Removal of London Stansted LYD 6R/5S SIDS

EGSS LYD SIDs
Stage 4 Update and Submit
Step 4B

Airspace Change Proposal
V1.0

NATS

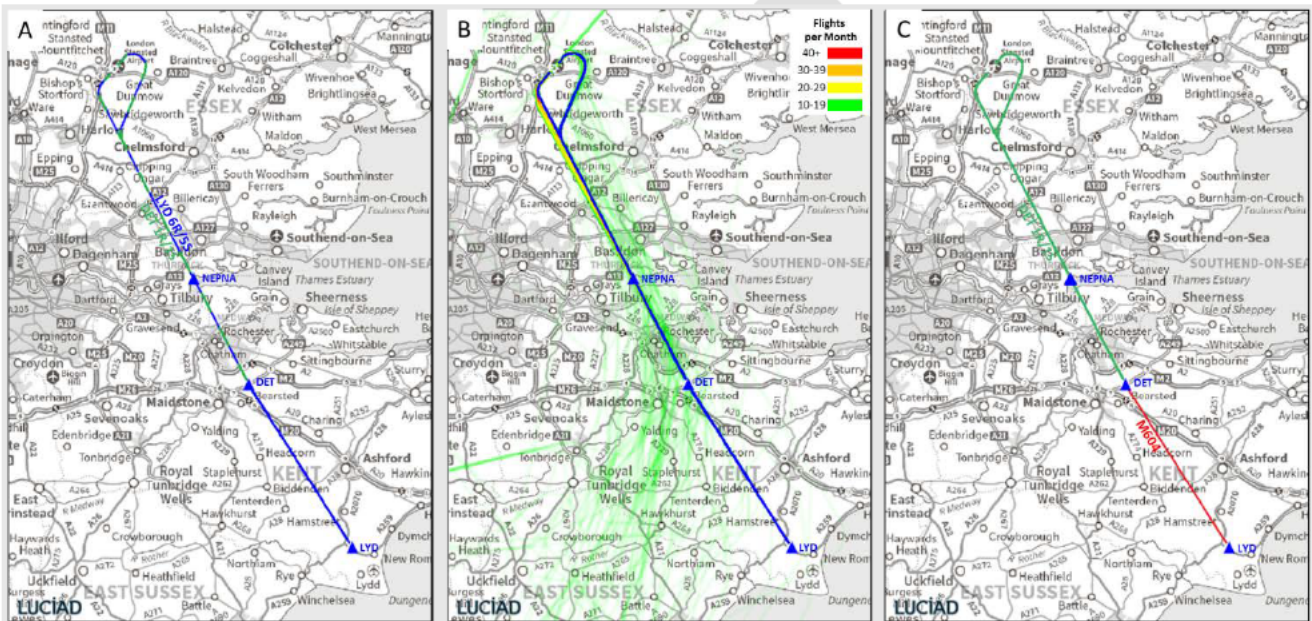
This ACP proposes that aircraft currently departing London Stansted using the LYD 6R/5S SIDs will fly the coincident DET 1R/1S SID. This SID finishes at DET. The remaining portion of the LYD SID will be replicated by extending UK ATS Route M604 from DET to LYD to replace the removed portion of the LYD SIDs. This new segment of M604 will be Route Availability Document (RAD) restricted so that it is only available to those flights which would have flown the defunct LYD 6R/5S SIDs.

These changes will maintain connectivity to the UK ATS network whilst ensuring there will be no changes to the frequency nor to the vertical or lateral dispersion of flights. The current LYD and DET SID routes along with a density plot of aircraft flying the LYD SIDs for June 2019 and proposed changes are shown in Figure 3.

Figure 4: LYD/DET SID Chart AD2.EGSS-6-4 with proposed deletions highlighted red.

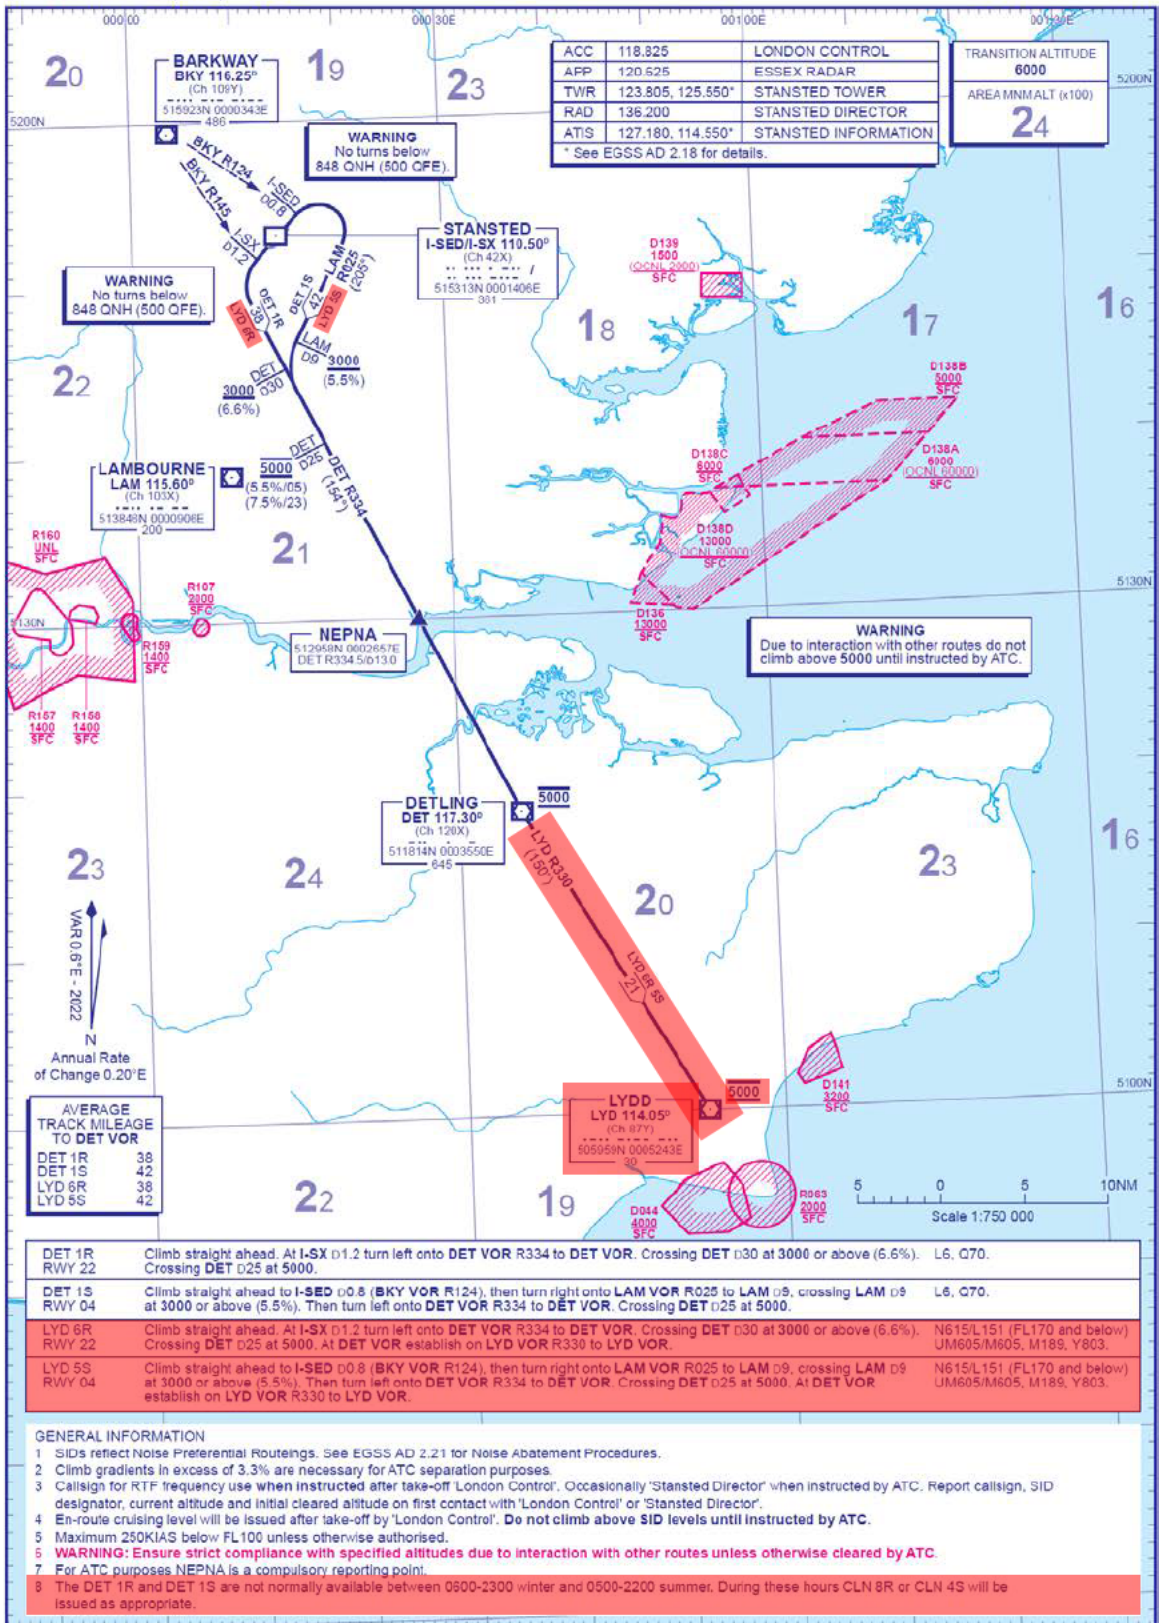
Currently the DET 1R/1S SIDs are not available H24, they are unavailable between 0500-2200 summer and 0600-2300 winter. There is no associated restriction with the LYD 6R/5S SIDs. The DET 1R/1S SIDs availability will be updated to H24 to ensure that aircraft departing Stansted via LYDD can continue to do so with no discernible difference to the aircraft tracks over the ground.

References to the LYD DVOR and LYD SIDs will be removed

The proposed changes to the LYD/DET SID Chart AD2.EGSS-6-4 are shown in Figure 4 below:
